ELLICOTT SAND AND GRAVEL LLC - SITE DEVELOPMENT PLAN

STAGE 1 OF 6 - SITE DEVELOPMENT PLAN - PPR234

EL PASO COUNTY SITE DEVELOPMENT PLAN
SITE DEVELOPMENT PLAN NOTES PAGE
FOR
SCHUBERT RANCH SAND RESOURCE
ELLICOTT, COLORADO

2	BY: _____ DATE: _____	EL PASO COUNTY DEVELOPMENT PERMIT SITE DEVELOPMENT FOR SCHUBERT RANCH SAND RESOURCE ELLCOTT, COLORADO	DATE: 08-02-2022 SPECIAL USE PERMIT APPROVAL - BCC	ELLCOTT SAND AND GRAVEL LLC 235 Franceville Coal Mine Road Colorado Springs Co 80929 phone: (602) 558-0846	PDC File # PPR234 DATE: 1/9/2023 FILE NAME: ESD-DR SITE PLAN DRAWN BY: ENW/S&S AS NOTED CHECKED BY: BHH
----------	-----------------------	---	--	---	--

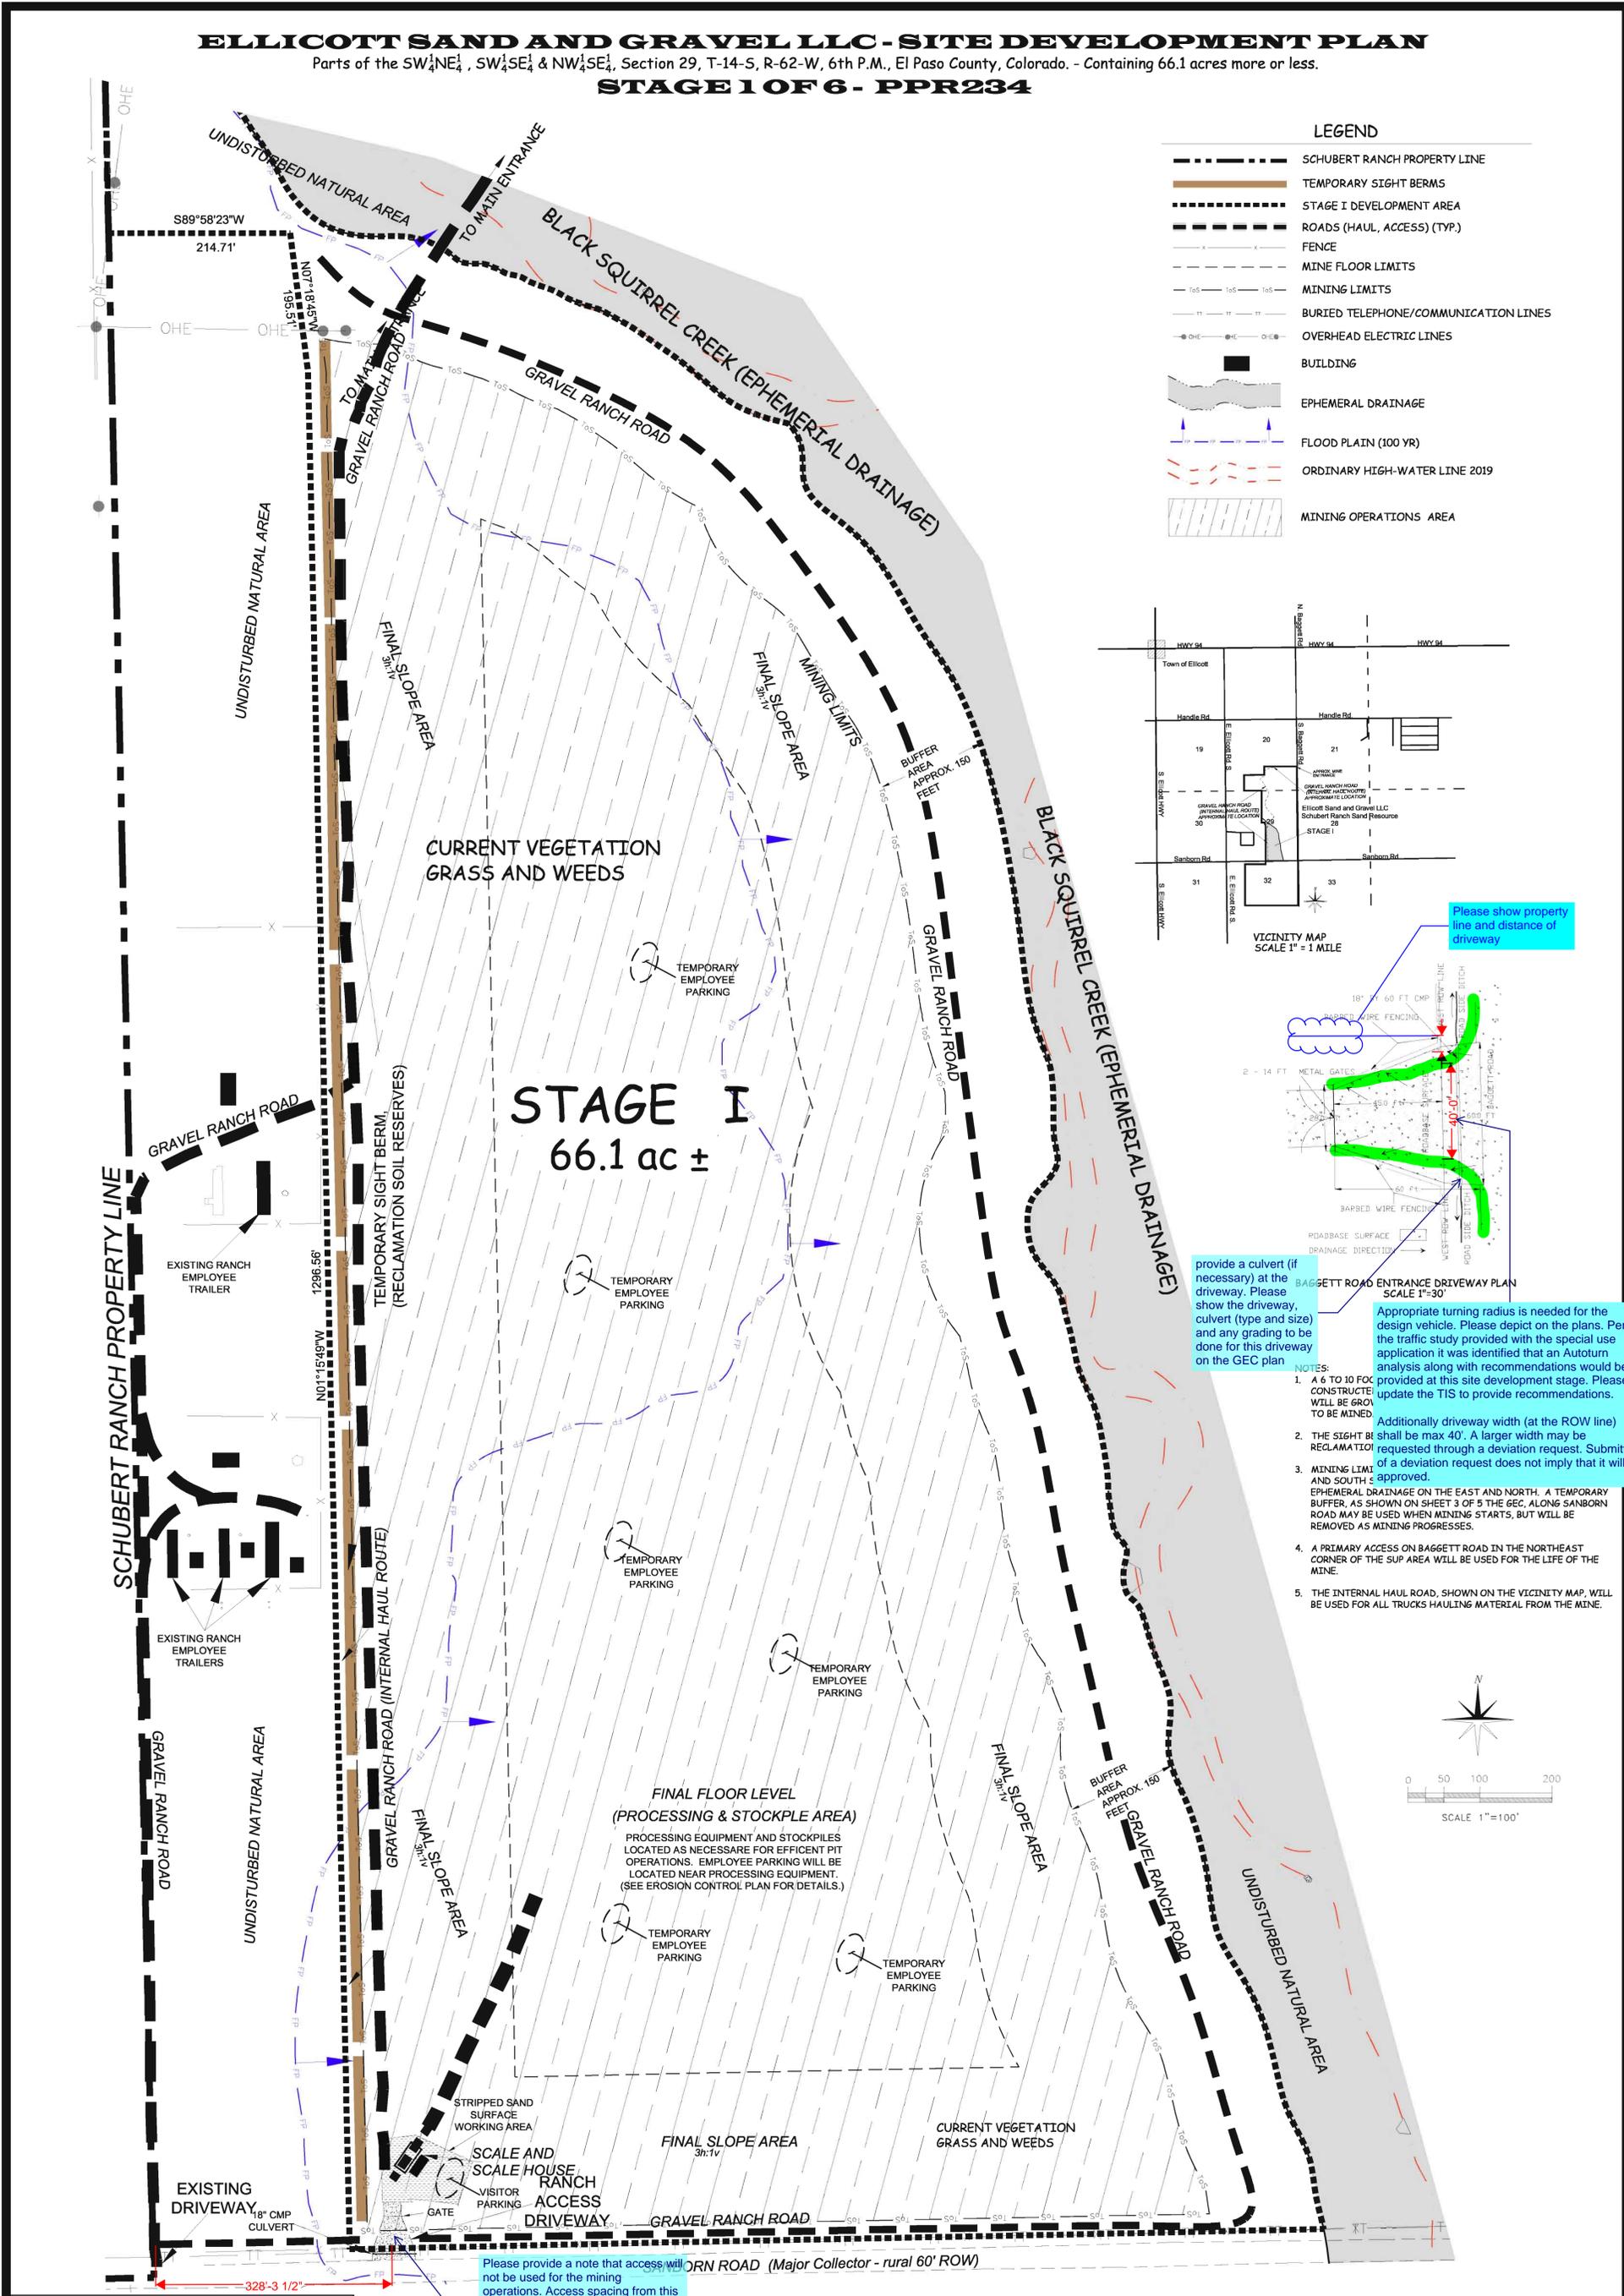
- provide a culvert (if necessary) at the driveway. Please show the driveway, culvert (type and size) and any grading to be done for this driveway on the GEC plan

- Appropriate turning radius is needed for the design vehicle. Please depict on the plans. Per the traffic study provided with the special use application it was identified that an Autoturn analysis along with recommendations would be provided at this site development stage. Please update the TIS to provide recommendations.
